CEC1702

Silicon Errata and Data Sheet Clarification

FIGURE 1: HIGH IBAT CURRENT DURING COIN CELL INSERTION

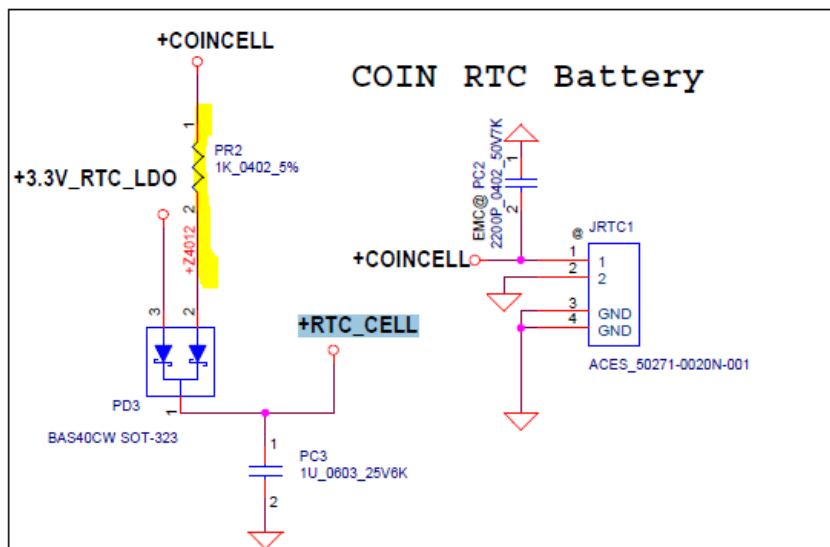
There could be a high I_{BAT} current on new coin cell insertion. During initial VBAT power rising, the VBAT circuit can enter a high current state causing a voltage drop across the 1K UL resistor.

- Under these conditions, the VBAT power on can stall in this high current state, with the VBAT on device pin between 0.7 and 1.2V.

Insert the coin cell and then apply VTR (i.e +3VALW). This enables VBAT low-power operation. A high I_{BAT} will not return on subsequent VTR power cycles.

Referring to the RTC Battery circuit shown in [Figure 1](#), applying VTR via the +3.3V_RTC_LDO signal, powers RTC_Cell (which is connected to VBAT) directly (without a series 1k resistor and hence no IR drop from the applied VTR), raising VBAT (RTC_Cell) to greater than 2.0 volts. This takes VBAT out of the “high current” region discussed above enabling normal VBAT low power operation.
